Access Compliance Report

Public Rights-of-Way

(Curb Ramps)

Intersection ID: 3282	Main Street: OAK_ST	Cross Street: ERNEST_RUSSELL_CT	Location: W
ADA ID: 5C9EE4C4F238	Ramp Type: PerpDiag	Initial Pass/Fail: Fail	Overall Compliance: No
Severity Score: 22.5			
Codes/Mitigation Info/Possible Solution		Field Measurements/Component Compliance

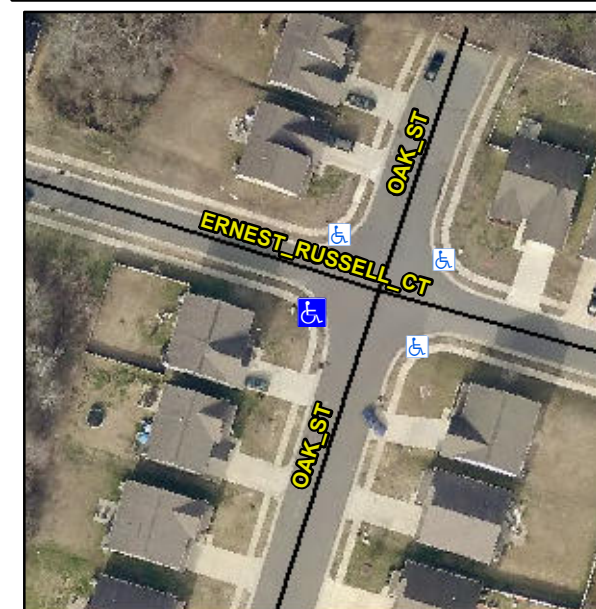
Not Found, R304.5.1, R304.2.2, R304.5.3

Compliance	Description	Data	Compliance	Description	Data
N/A	Ramp Length (in)	50.0	No	Ramp Slope (%)	11.0
No	Ramp Width (in)	42.0	No	Ramp XSlope (%)	4.2
N/A	Flare Type LT	N/A	N/A	Flare Type RT	N/A
N/A	Flare Slope LT (%)	N/A	N/A	Flare Slope RT (%)	N/A
N/A	Flare Traversable LT?	N/A	N/A	Flare Traversable RT?	N/A
N/A	Landing Length (in)	N/A	N/A	DWS Provided?	N/A
N/A	Landing Width (in)	N/A	N/A	DWS Contrast?	N/A
N/A	Landing Slope (%)	N/A	N/A	DWS Length (in)	N/A
N/A	Landing X Slope (%)	N/A	N/A	DWS Full Width?	N/A
N/A	Landing Curb? (Y/N)	N/A	N/A	DWS Offset (in)	N/A
N/A	Shared Landing?	N/A			
N/A	Gutter Ponding?	N/A	N/A	Gutter Slope (%)	N/A
N/A	Gutter Lip Ht (in)	N/A	N/A	Gutter X Slope (%)	N/A
N/A	Painted X Walk1?	No	N/A	Painted X Walk2?	No
	X Walk 1 Direction	To SE		X Walk 2 Direction	To NE
N/A	X Walk 1 Width (in)	N/A	N/A	X Walk 2 Width (in)	N/A
	X Walk 1 Slope (%)	1.7		X Walk 2 Slope (%)	3.2
	X Walk 1 X Slope (%)	2.6		X Walk 2 X Slope (%)	0.5

Remove & Replace Curb Ramp With Two New Directional Ramps or Equivalent.
